WATER RESOURCES
WESTERN REGIONSTATE OF IDAHO
DEPARTMENT OF WATER RESOURCES
APPLICATION FOR PERMIT
To appropriate the public waters of the State of IdahoIdent. No. 63-334691. Name of applicant(s) Robert H West and/or Alasya N West Phone 208/939-0719
Name connector (check one): ☐ and ☐ or ☒ and/orMailing address: 5035 Willow Creek Road City EagleState Idaho Zip 83616-2011 Email: rhwest@aol.com2. Source of water supply ground water which is a tributary of _____

Re: Application for Permit No. 63-33469

RE: Application for Permit No. 63-33469

Well_Log ID	Updated M.P. Elevation	SWL	WL Elevation	WL Date
05N01E29DAD1	2786	228.00	2558	3/24/2009
		228.57	2557	6/24/2009
		230.66	2555	10/5/2009
		228.92	2557	12/21/2009
		229.89	2556	3/31/2010
		229.06	2557	6/28/2010
		231.11	2555	9/29/2010
		229.21	2557	12/28/2010
		228.81	2557	3/28/2011

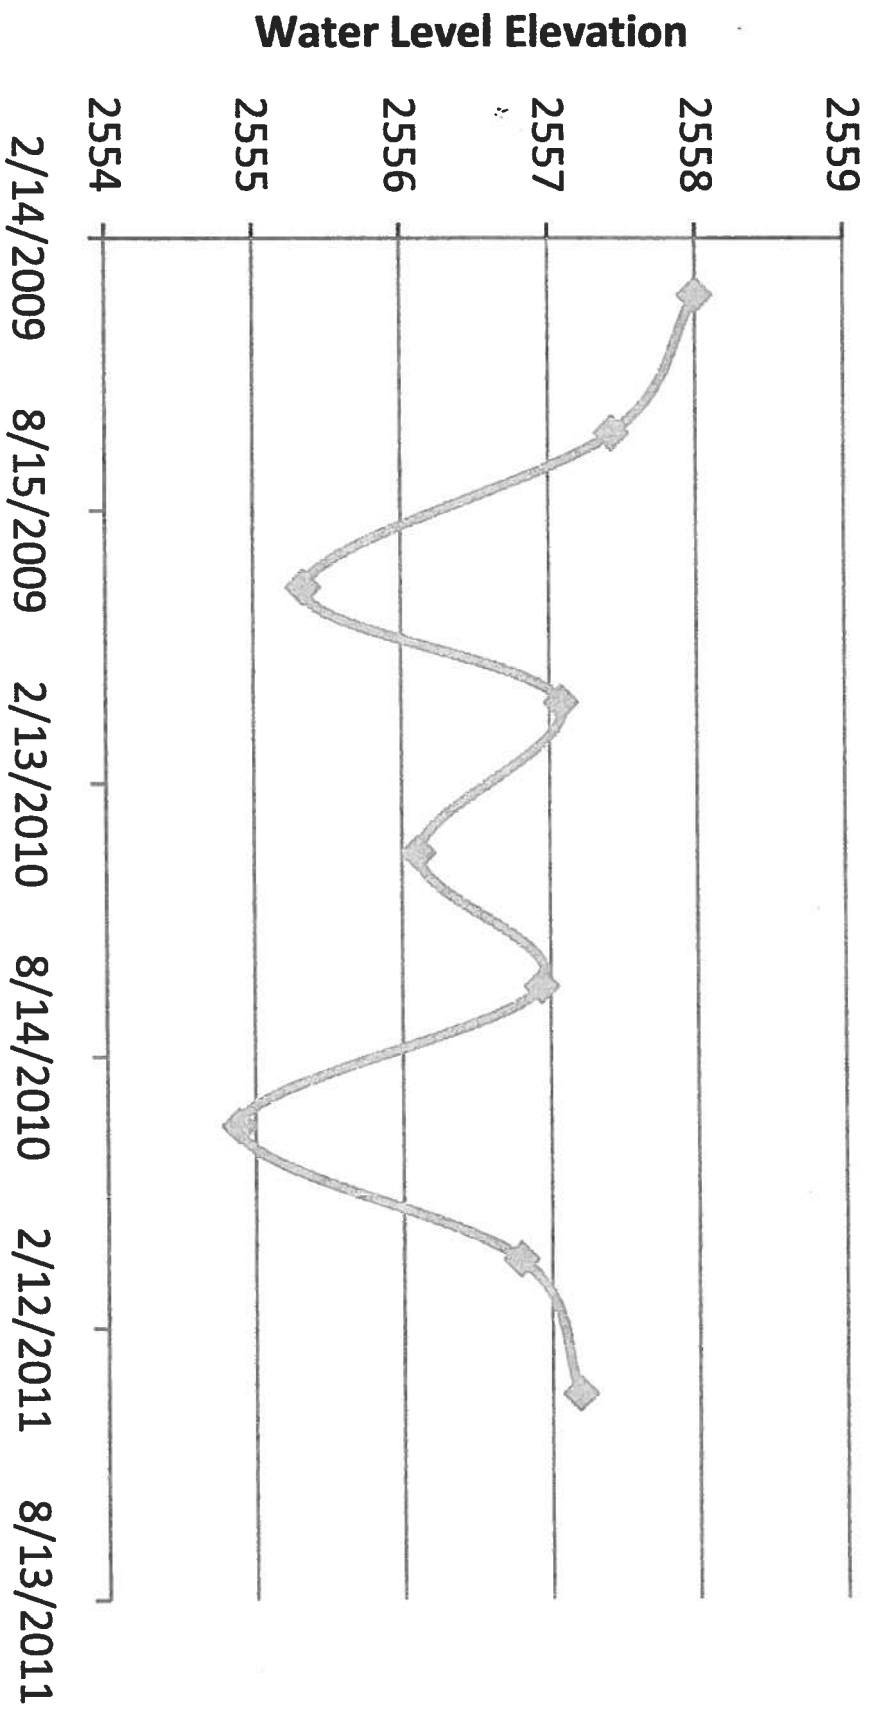
Dennis Owsley PG, Technical Hydro Geologist for the Department of Water Resources has been monitoring my well, Well log ID 05N01E29DADI, GPS Site ID Number A0013248, since March of 2009. I have attached a copy of Mr. Owsley's letter to me dated April 5, 2011. As you can see my water levels have been very stable.

Below are the water level measurements we have collected from your well. The most recent measurement was collected at the end of March, with a reading of 228.81 feet below the top of the casing. To view this data and other water levels in the North Ada County area, please visit the website <http://www.idwr.idaho.gov/hydro.online/gwl/default.html>.
